TECHNICAL SERVICE BULLETIN

TIMING BELT SETUP FOR T285 3.0L 1999 SPLIT YEAR APPLICATIONS

BULLETIN TSB_031

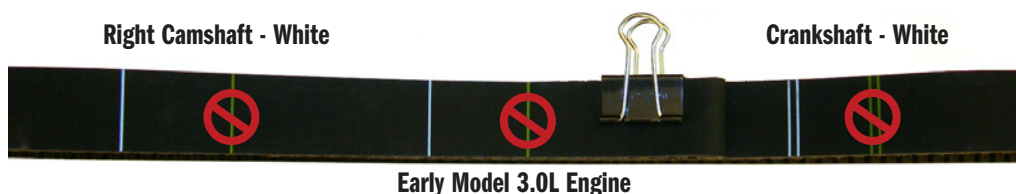
This tensioner/bracket system is an indicator that you have an early model system. In this case you will use the WHITE marks on the belt for the right camshaft and crankshaft during setup.

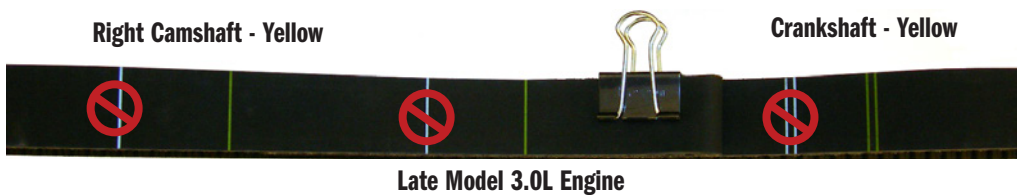
This tensioner/bracket assembly is an indicator that you have a late model system. In this case you will use the YELLOW marks on the belt for the right camshaft and crankshaft during setup.

Both versions of the 3.0 liter engine utilize the same lower idler pulley (T42086)

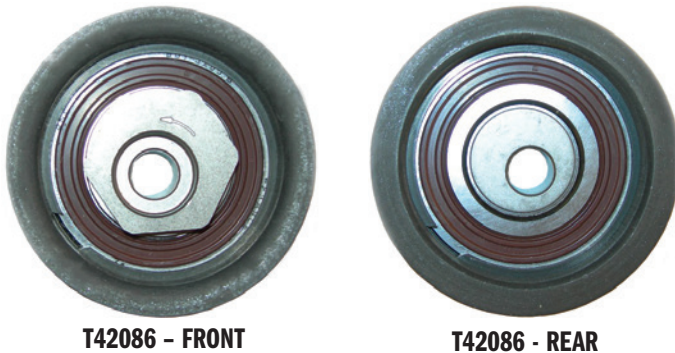
The original design utilized a fixed lower idler which is no longer available from Gates. T42086 is available and is an adjustable idler to aide in setup of timing system.
